ADDENDUM TO REQUEST FOR PROPOSAL DOCUMENT
FOR
Moosomin Dam
Service Contract No. 5
Dam Safety Review
REQUEST FOR PROPOSAL # 4547:928-7P11-0-S1-5

Addendum No. 3

Q&A:

Mark	Grid Ref.	Nature of Revision	Date	Eng. By Whom

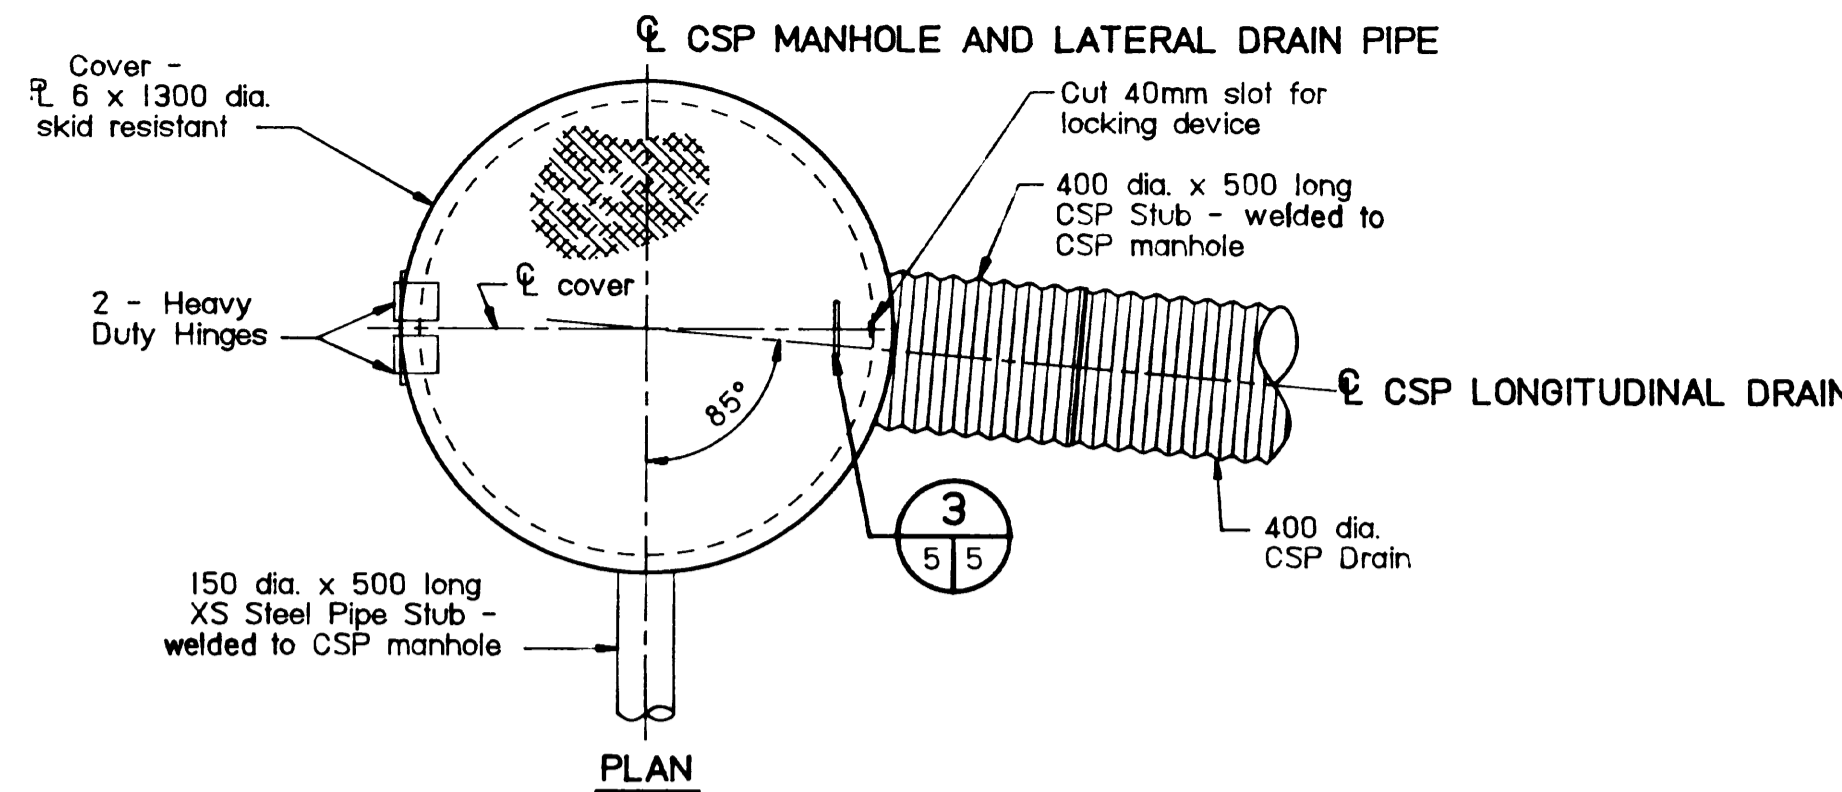
Q8 - Can AAFC provide additional details on the CURRENT layout of the underslab drainage system including the diameter of the drain pipes. The drawing provided (C208544) only displays two transverse drains that have been removed. We are interested in the pipe diameter and length of transverse drains.

A8 - The drawing provided with the configuration of the spillway did not include all the details of the drainage system. In 1990 and in 2001, the drainage system was repaired and the original transverse drain pipes were replaced with 150mm dia PVC pipes. The attached drawings show the relevant drainage system details.
